PLANT NAME: D C Cook #1

Donald C. Cook Nuclear Plant Unit No. 1  
Docket No. 50-315  
DPR No. 58

This letter is in response to Mr. Dennis L. Ziemann's letter of September 3, 1976 which requested additional information concerning Exxon Nuclear Company Reports XN-76-25 and XN-75-39. We submitted these reports in support of our July 20, 1976 request for an amendment to the above captioned operating license to permit operation at 100% of rated power for fuel cycle 2.

QUESTIONS AND ANSWERS FROM ENCLOSURE 1  
(concerning XN-76-25)

FIGURE 1. ENC Fuel Rod Length Change Data

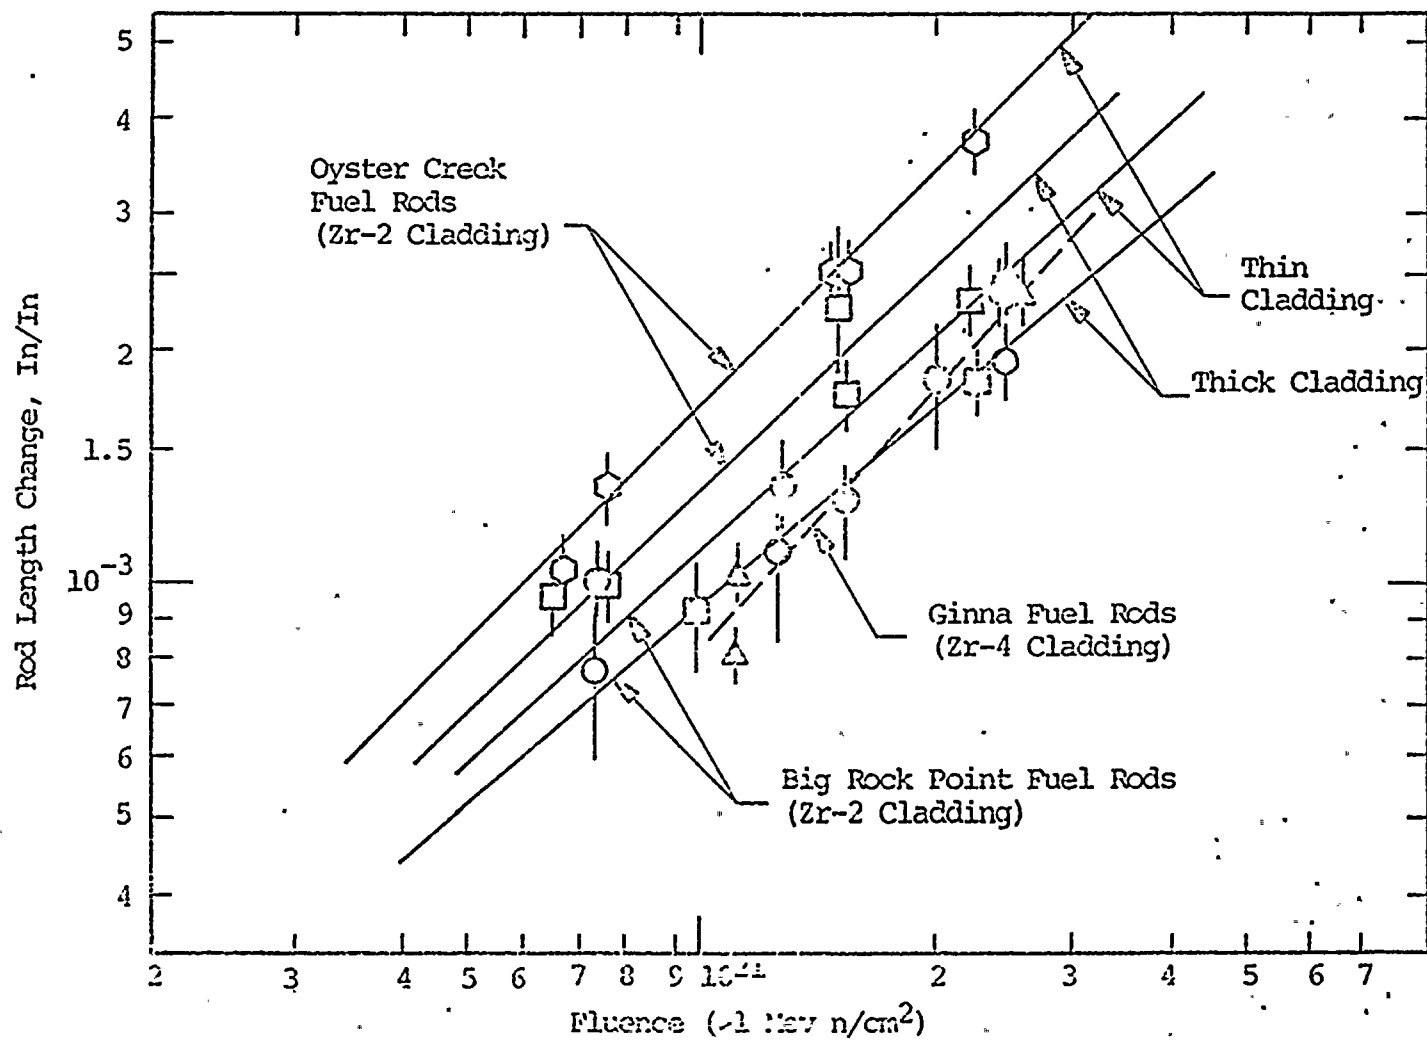
Please cite the reference in which data of Exxon fuel rod length changes with burnup is reported.

ENC has measured fuel rod length changes on fuel from three reactors: Oyster Creek, Big Rock Point, and R. E. Ginna. Approximately 100 rods have been measured, covering burnups from about 6000 MWD/MTM to 19,000 MWD/MTM. The results of these measurements are shown in the attached Figure 1. Maximum fast flux fluence for D. C. Cook is calculated not to exceed  $7 \times 10^{21}$  n/cm<sup>2</sup> ( $> 1$  Mev). Using the R. E. Ginna fuel rod length change as a basis, the fuel rod extension would be less than  $8 \times 10^{-3}$  in/in or 1.15 inches.
